City of Surrey  
**PLANNING & DEVELOPMENT REPORT**

Application No.: 7919-0263-00

to permit the development of a 6-storey apartment building.

ADP REVISION SET: CITY FILE # 19-0263-00

SITE LAYOUT

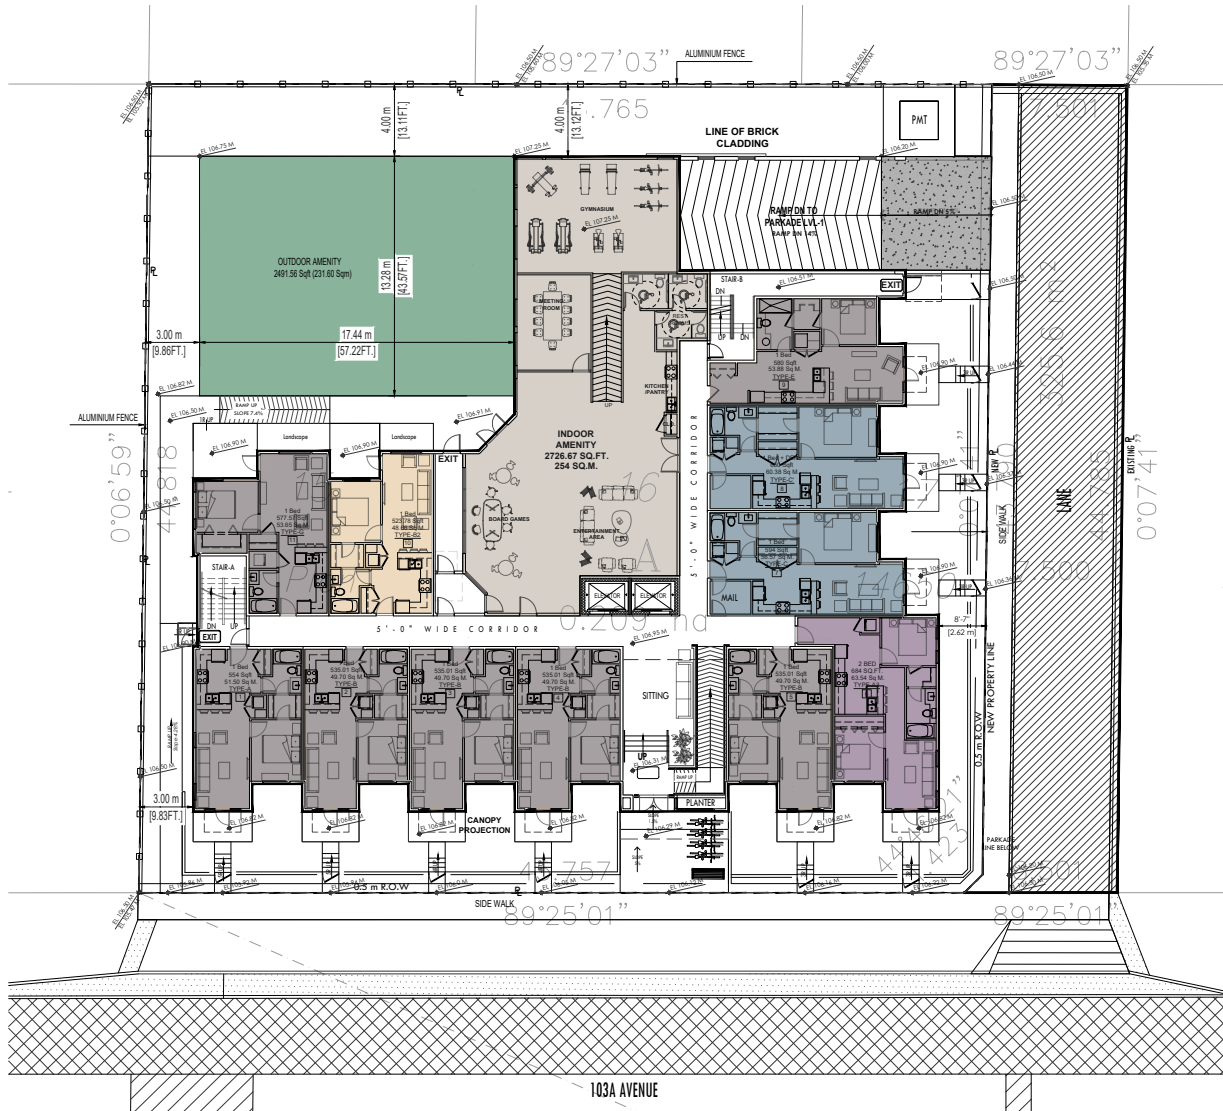
- Consider shifting the pathway/ramp on the north at outdoor amenity space at grade to add more buffer and separation to the patios.  
*We have now shifted the ramp on the north at outdoor amenity space and provided the landscape buffer. Updated, Please refer to the sheet no. ADP-1.0 for more updates.*

PARKADE  
PLAN-1

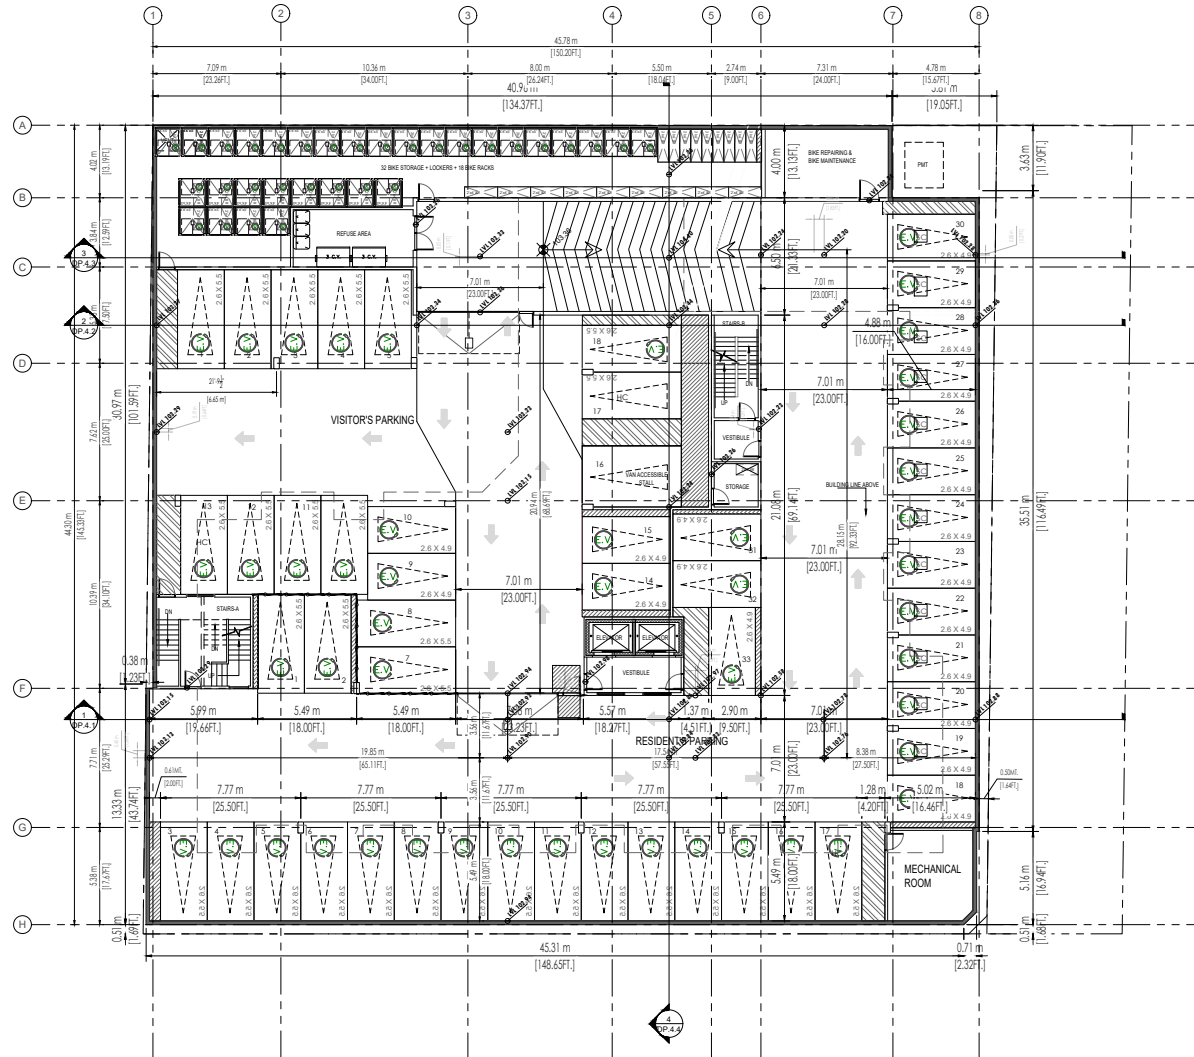
- Consider consolidating all the bike storage top the north side of P1 to provide more convenient access to the entry ramp.  
[Updated, Please refer to sheet, D.P.2.0 & D.P.2.0 \(A\) For further details.](#)

- Consider increasing the size of the bike maintenance area and accommodating more e-bike charging.  
Updated, Please refer to the sheet ADP.2.o and ADP.2.o (A).

MAIN FLOOR PLAN

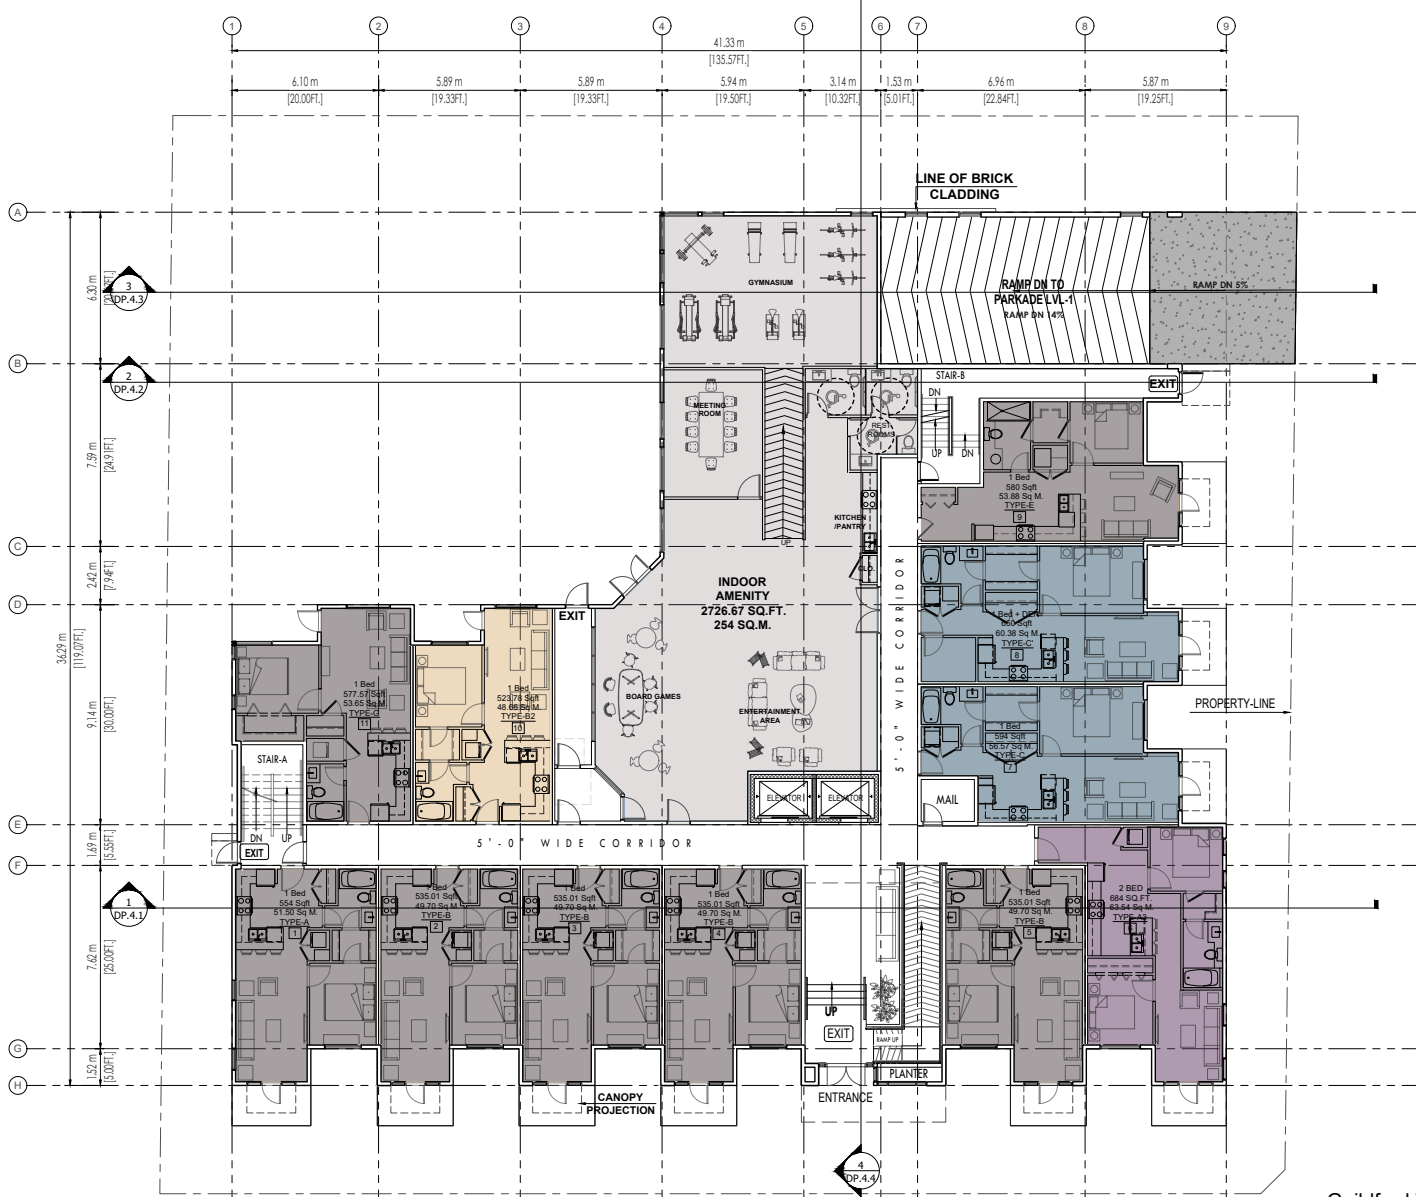
- Consider resolving exiting in Exit Stair 2 at L1 as early as possible.  
[Updated, Please refer to sheet D.P. 2.1 \(Main Floor Plan\).](#)
- Consider targeting 5% of your suites as Adaptable.  
[We have Proposed 4 Adaptable Units. Please refer to sheet D.P.2.2 \(Second Floor Plan\).](#)
- Consider engaging an elevator consultant to confirm elevator requirements.  
[Noted.](#)
- Consider using energy and thermal comfort modelling to inform your design development. Use future climate files to best understand the resiliency of the project.  
[Noted.](#)
- Consider electric charging stations for electric bike charging, and a bike maintenance facility.  
[Noted.](#)
- Consider providing a roof material with a higher SRI value.  
[Noted.](#)

- Review your underground parking ramp for potential headroom clearance issues with unit F on level 1.  
[Updated, please refer to sheet D.P.2.1. \(Main Floor Plan\).](#)

DRAWING TITLE:  
**ROOFTOP AMENITY PLAN**

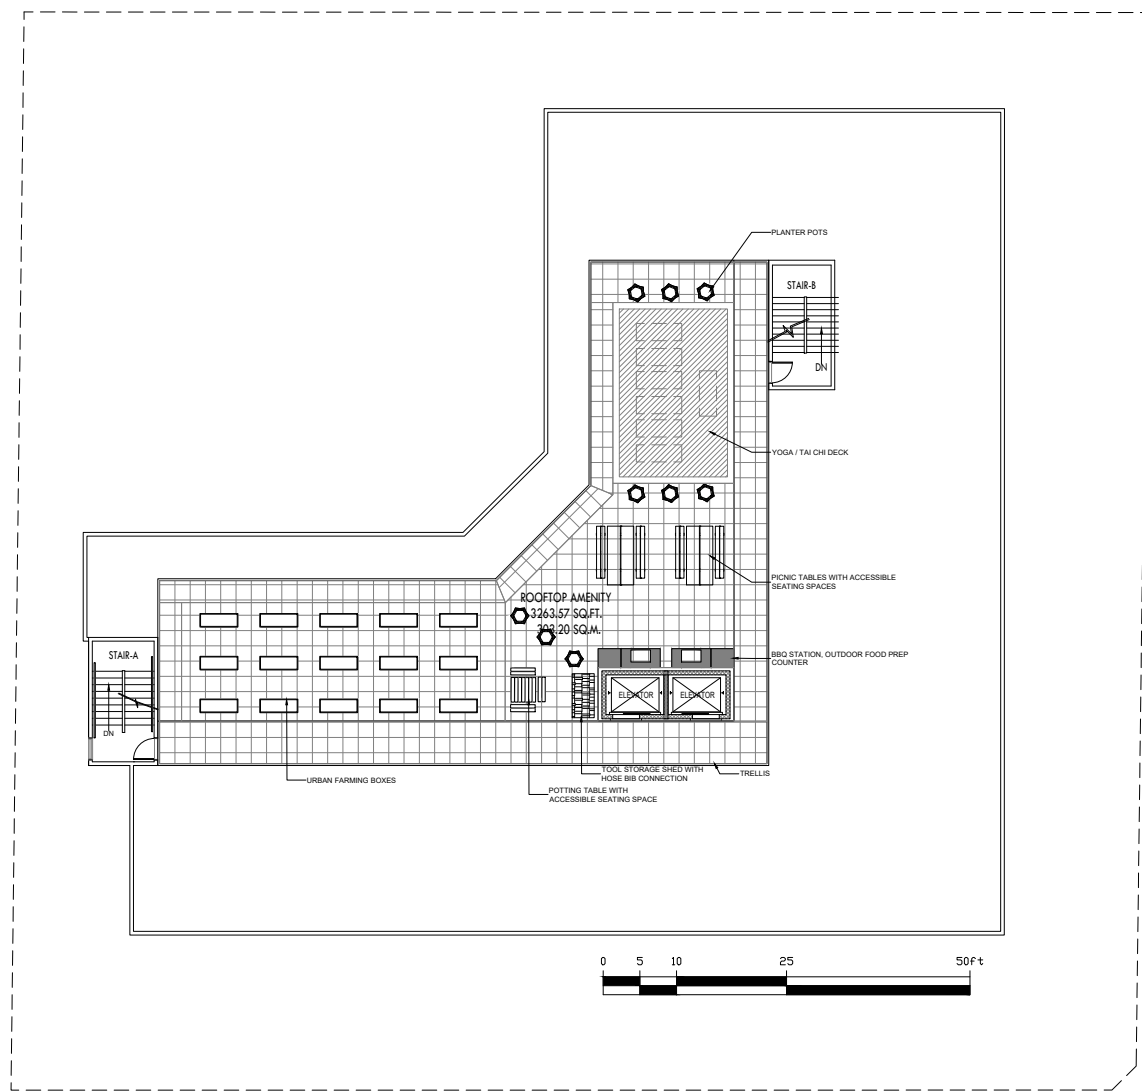
- The roof deck is a great addition to the project. Consider adding an additional trellis element to provide shading off the elevator.  
*We have specified a trellis structure to provide shade at the elevator doors.*
